**Southern River Precinct 3D
Local Water Management Strategy**

September 2017

ADDENDUM TO SOUTHERN RIVER 3D LWMS (ISSUE 7) IN RESPONSE TO COG'S COMMENTS DATED 22 MAY 2017					
Section	Reference Section	Comment on	Required Action	Bioscience Response	LWMS (Issue 8) PDF Page
		Required numbers of hard copies and soft copies are to be submitted according to the checklist provided at City of Gosnells website. This will help minimizing the time required for the assessment as three different departments are being involved in assessment. Go to the City of Gosnells home page and follow the link provided below. Gosnells Home page eCity Engineering Subdivisions of subdivision documents	Provide numbers of copies as per the checklist	3 hardcopies and 1 soft copy were sent to the City of Gosnells	n/a
		Provide a separate sheet attached to the front of the report with responses to the City's previous comments and reference to the updated sections. This will facilitate easy of our assessment and outline where the previous comments have been addressed or indicate why not been addressed.	Provide responses as requested before update the document. Happy to have a meeting if required	This is it.	n/a

DRAWING NUMBER:
1201008-201

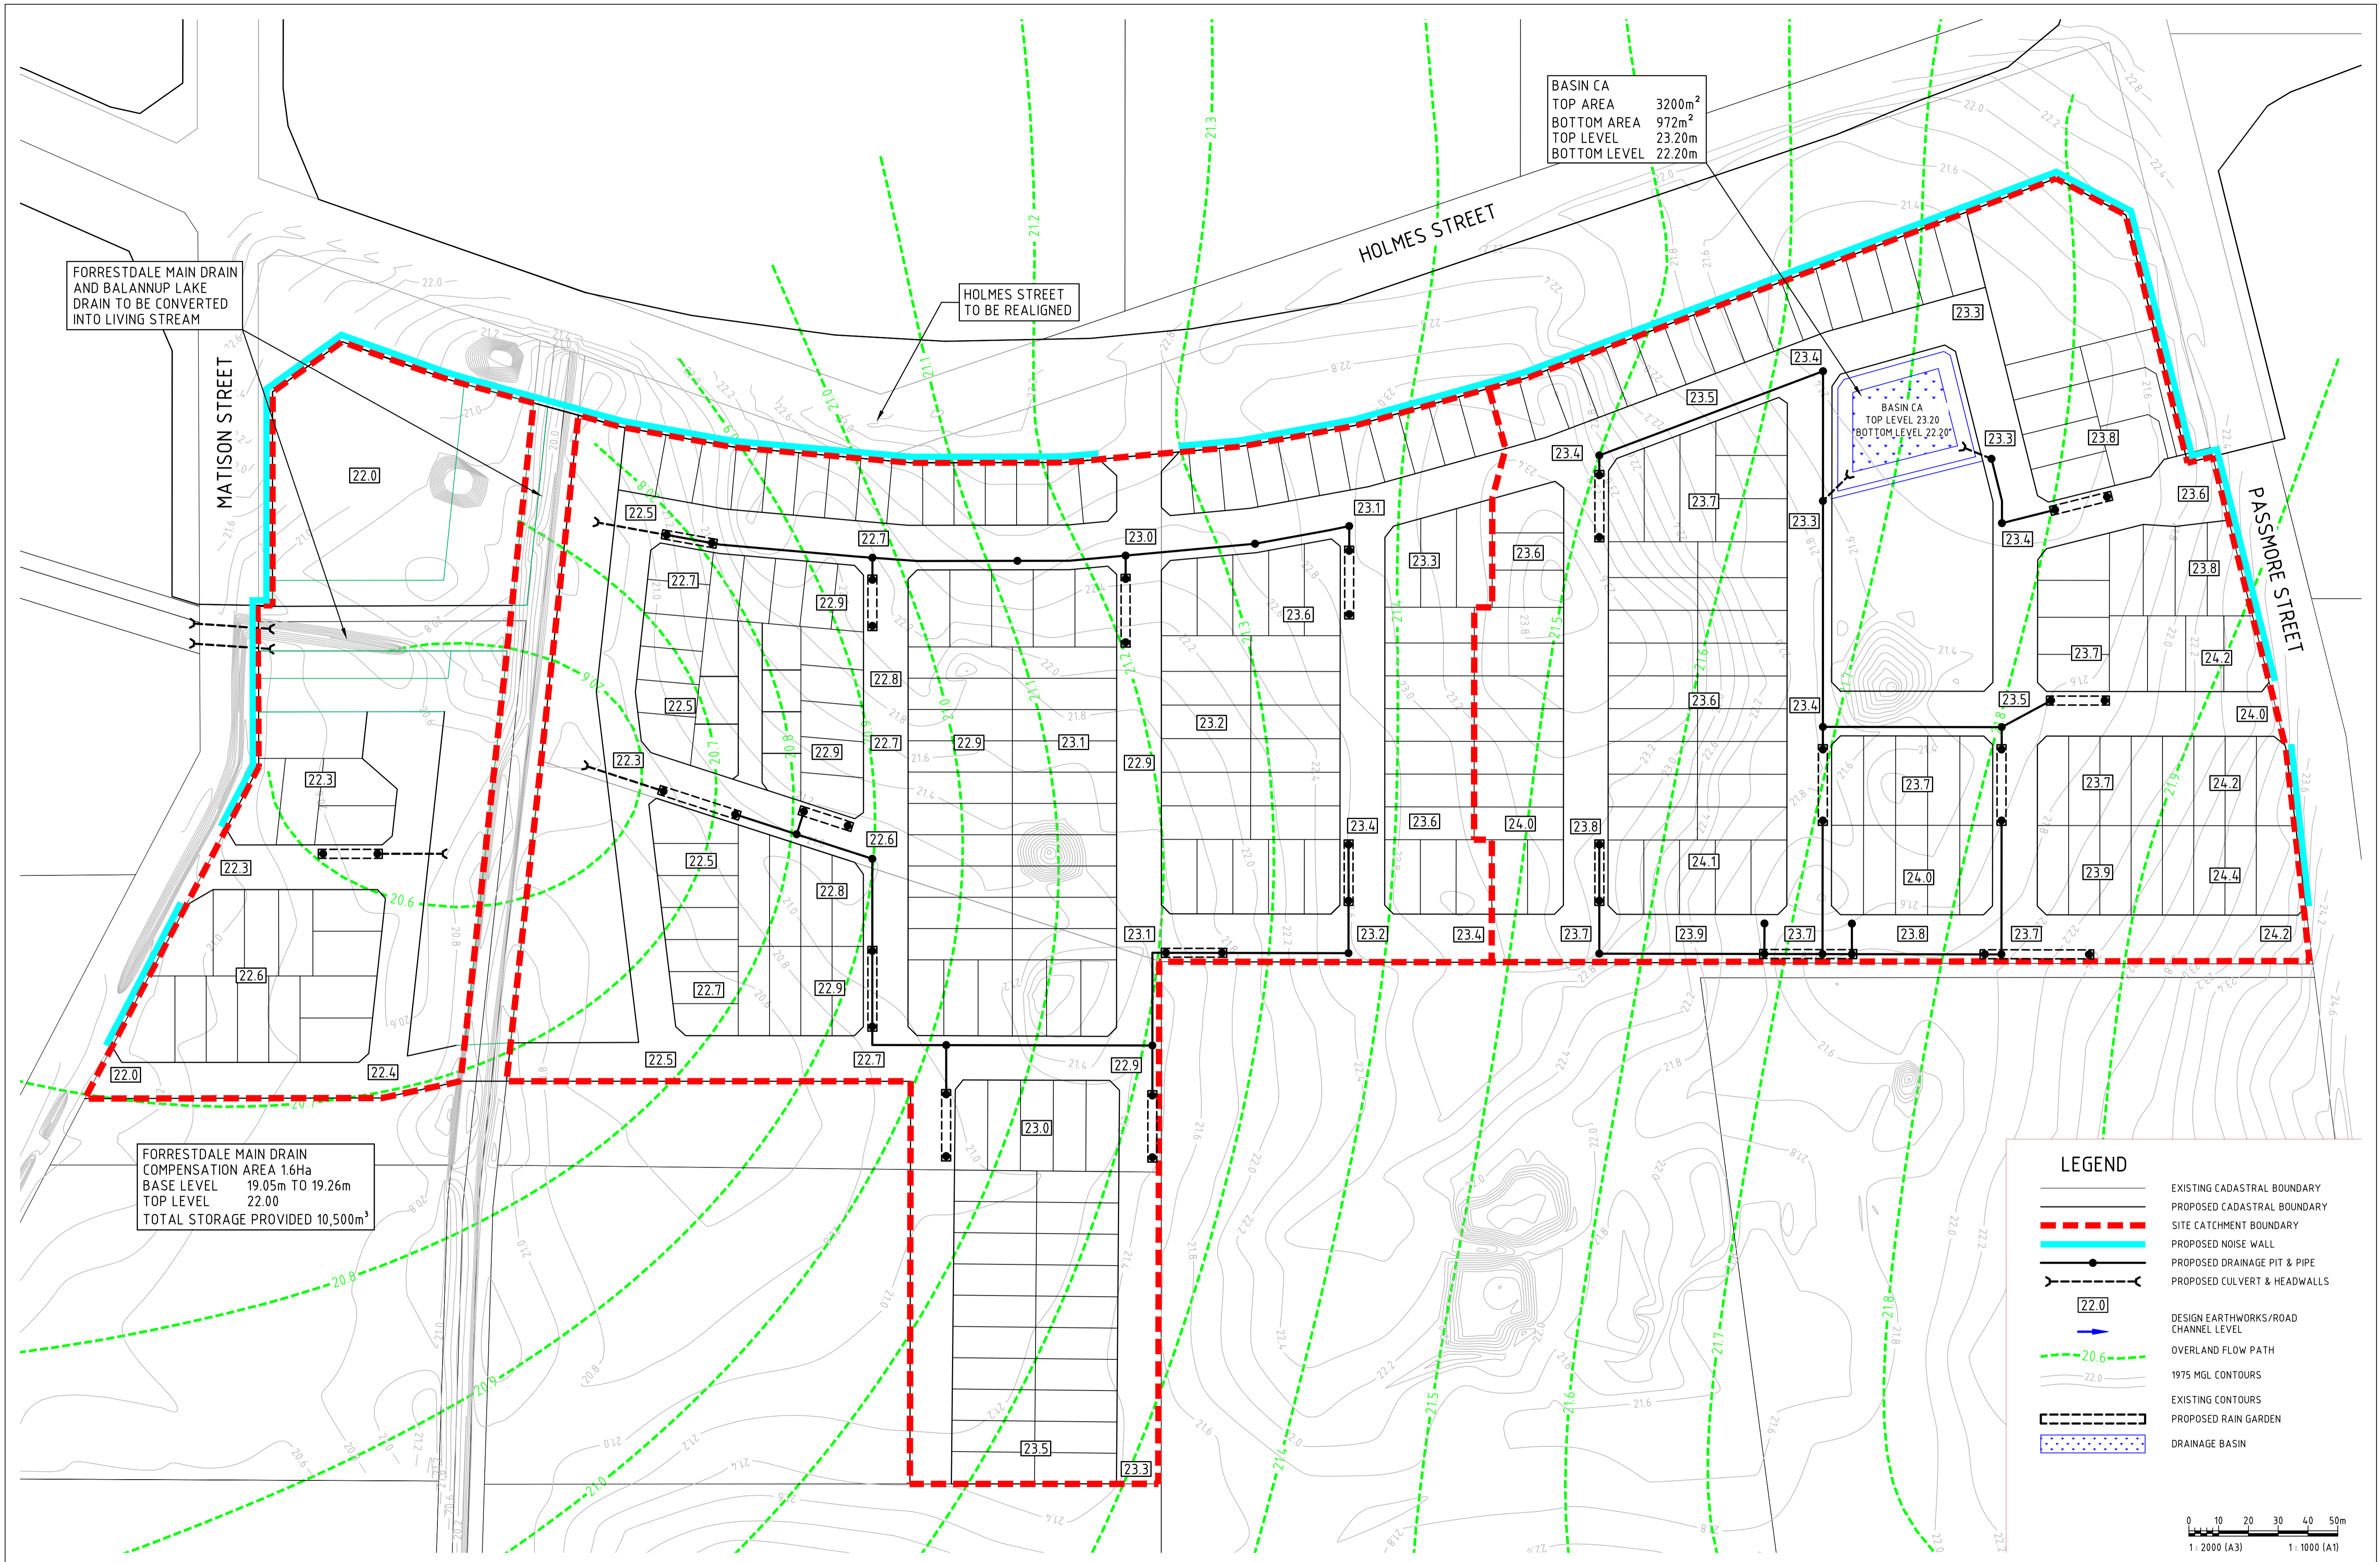
<ul style="list-style-type: none"> Minimum fill levels are maintained as per drawing 1201008-201 (Appendix C of the proposed LWMS). <p>Please note that this is not an acceptance of the design for the proposed living stream profile for the Forrestdale Main Drain which is still undergoing assessment.</p> <p>If you have any questions regarding the above please feel free to contact me to discuss.</p> <p>Regards, Christina Young Senior Asset Investment Planner Asset Investment Planning Metro Water Corporation T: (08) 9420 3673</p> <p>"</p> <p>Note that both the City of Gosnells and DWER approved the change in writing on 7 August 2017 and 8 August 2018 respectively.</p>	
		<p>Land matter issues will also need to be addressed with the creation of a Maintenance Agreement for the living stream between the City of Gosnells and the Water Corporation.</p>		<p>This will be addressed by both involved parties</p>	<p>n/a</p>

PROFILE THROUGH LIVING STREAM SECTION OF FORRESTDAL MAIN DRAIN
NTS

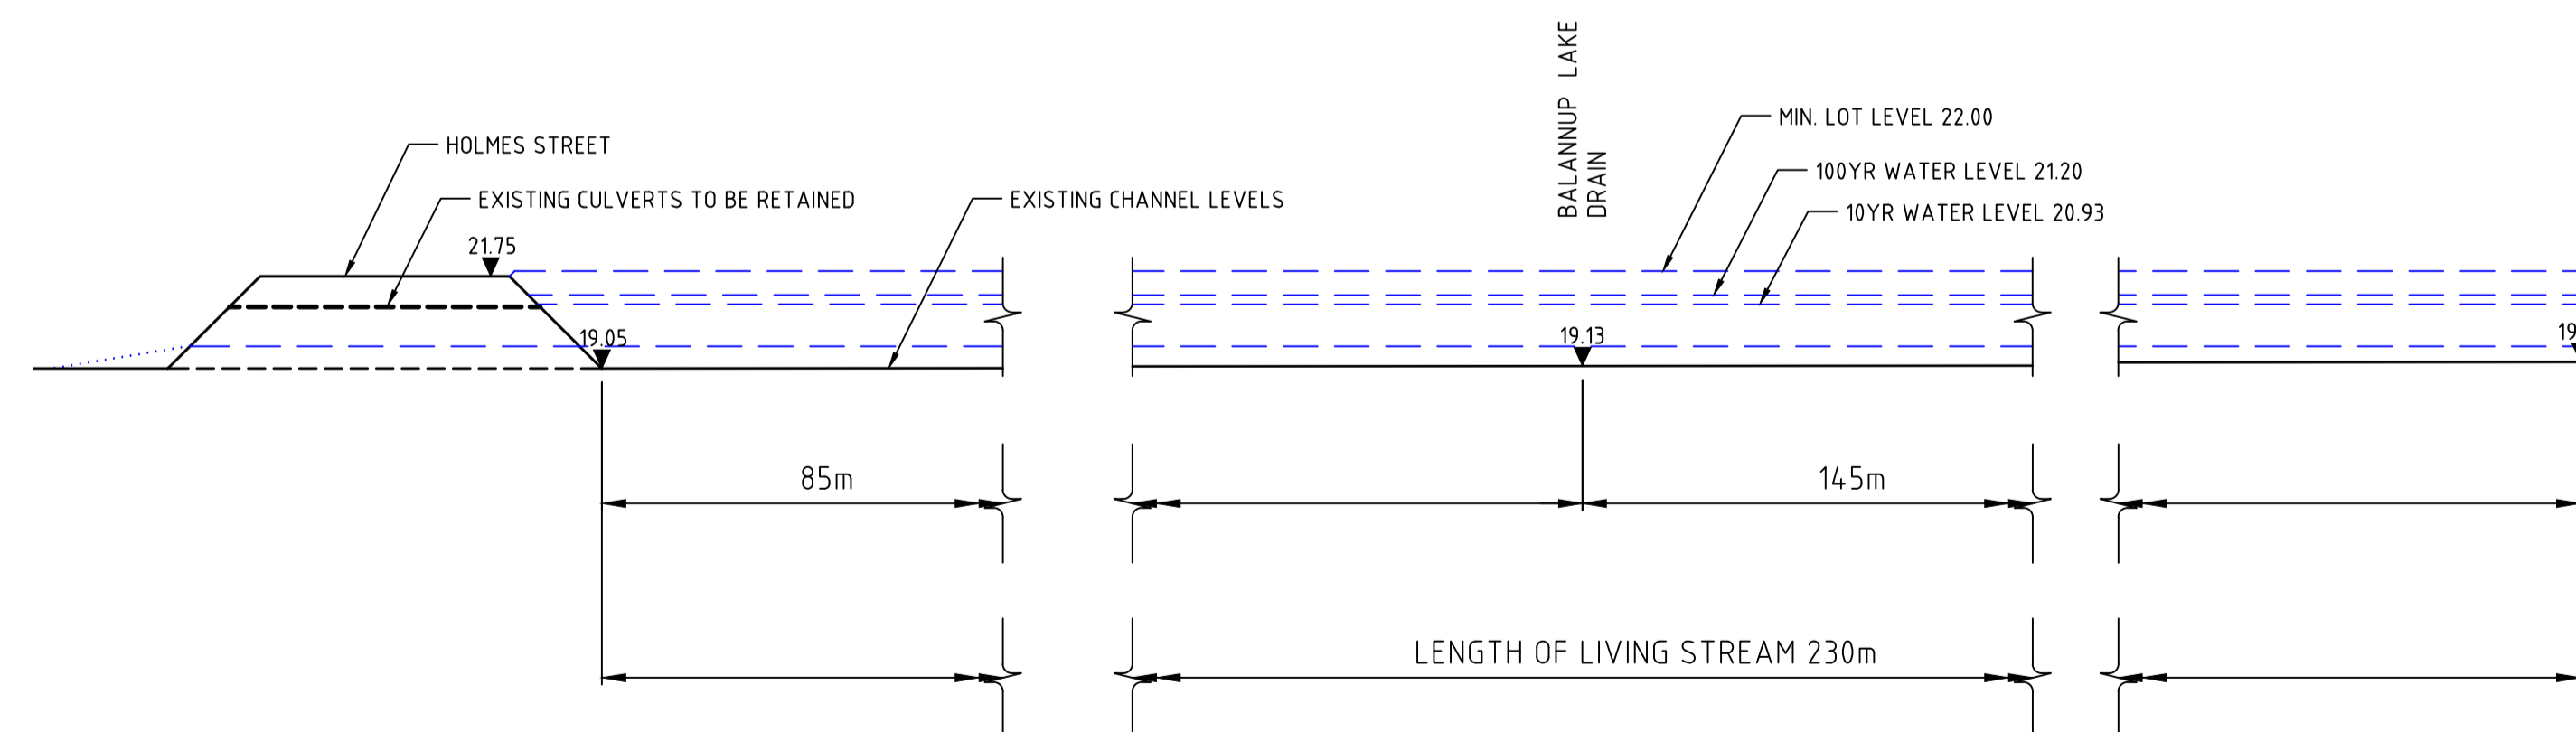
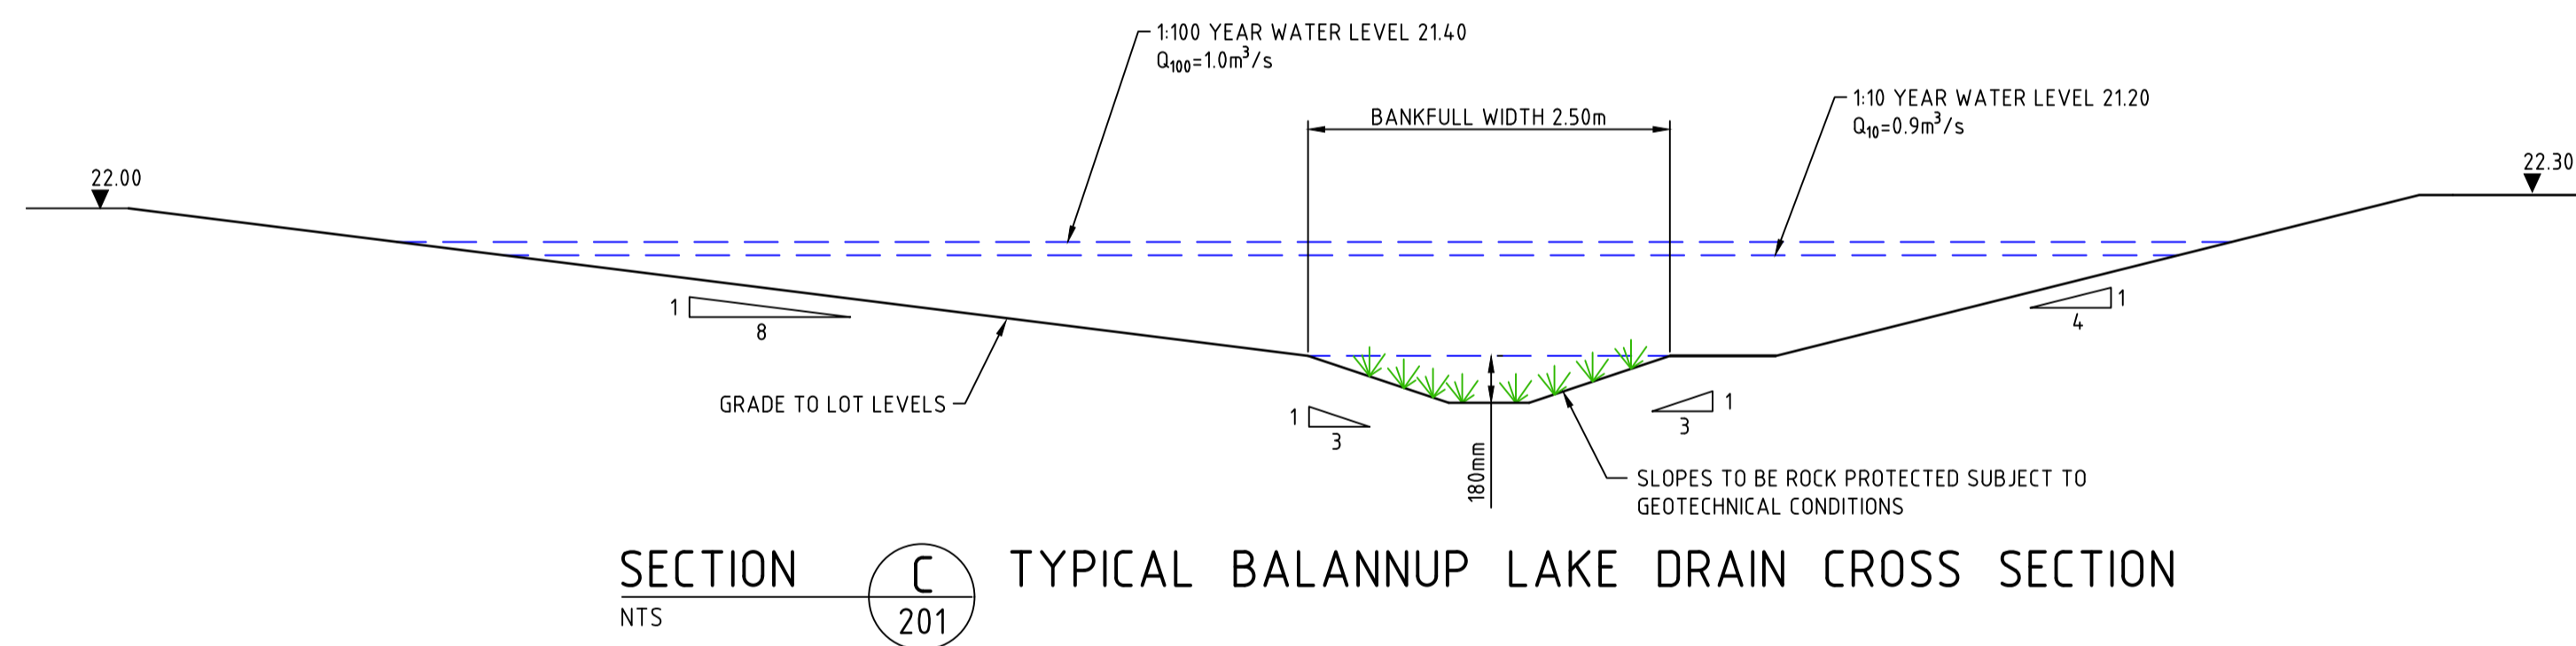
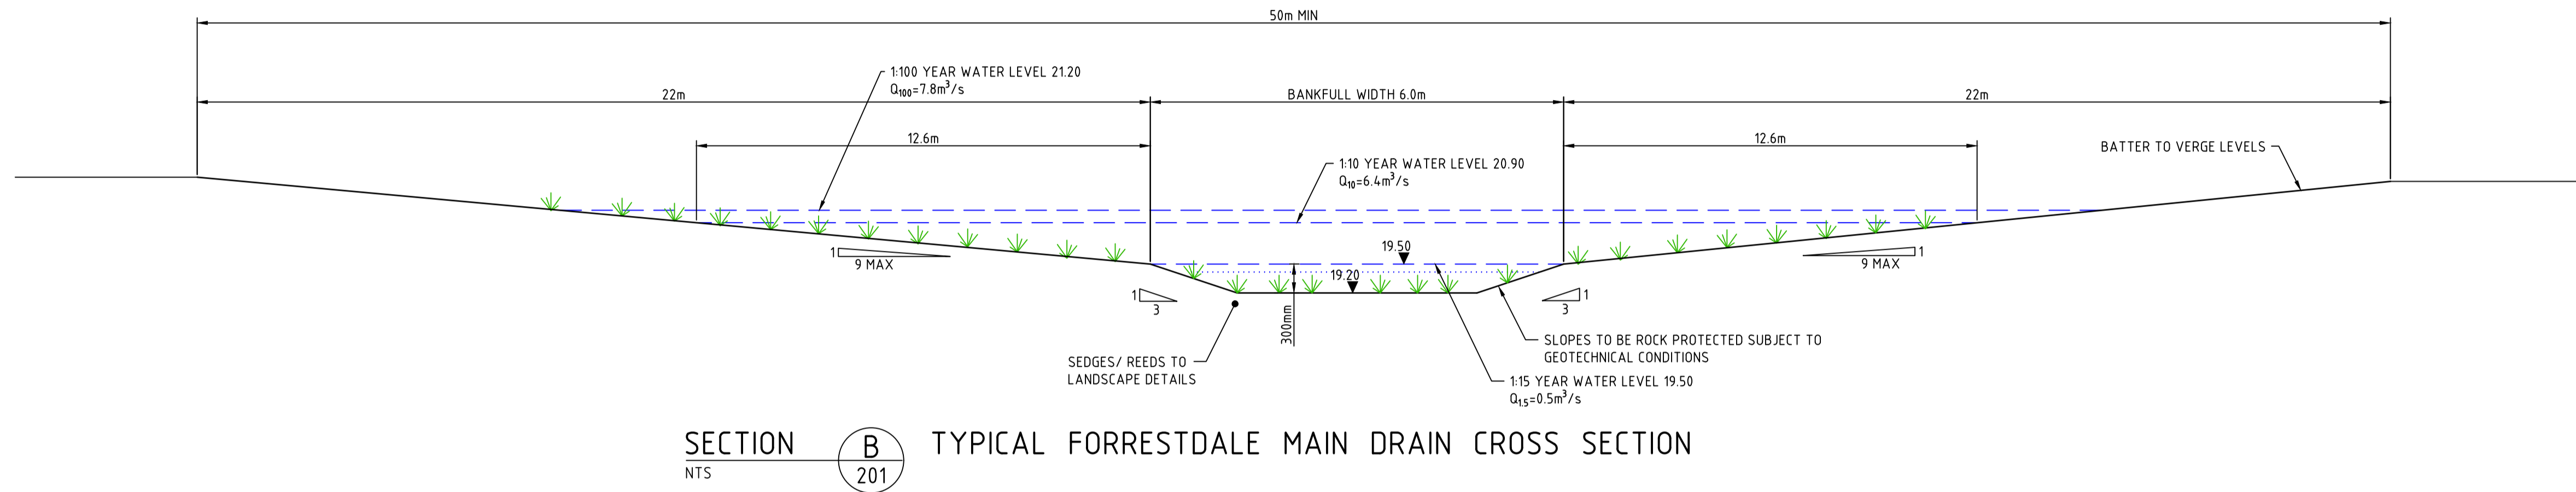
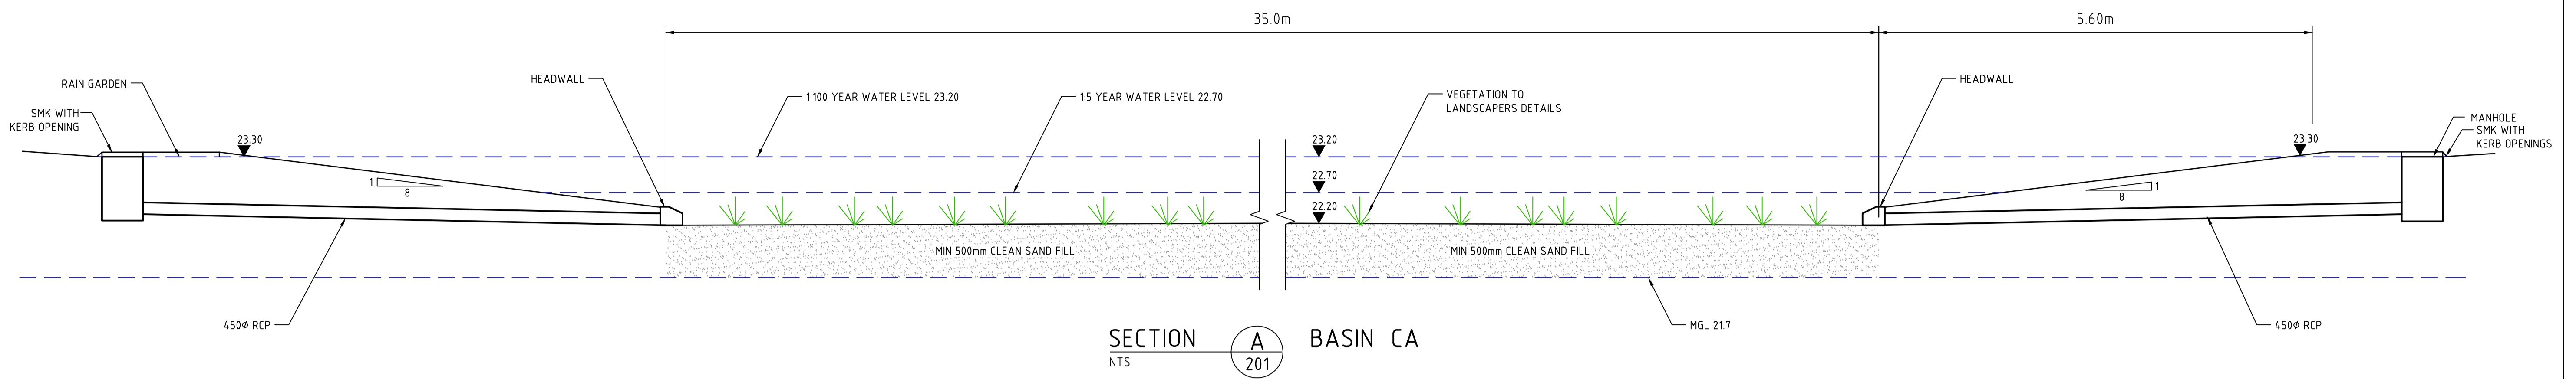
<p>Stormwater Management Strategy (Section 6)</p>	<p>The provided conceptual cross-section design for the FMD widening and Balannup Drain living stream is not consistent with the DoW living stream design criteria. Please refer to the living stream advice below and modify the cross-section (refer to Appendix C, SD-DP-17) and conceptual design (refer to Figure 10c) for the living stream.</p> <p><i>Bioscience comment: Shawmac have amended all plans</i></p> <p><i>The living stream should be designed in such a way that the design reflects the</i></p>

The FMD requires widening as per the ADS. The ODP is to provide a 1.5ha online compensation basin as shown in Figure 3 of the ADS (**Appendix B**). The online basin has been included in the Shawmac drainage design plans (**Appendix C**). The FMD living stream cross section has been amended as directed, to provide max 1:9 slopes.
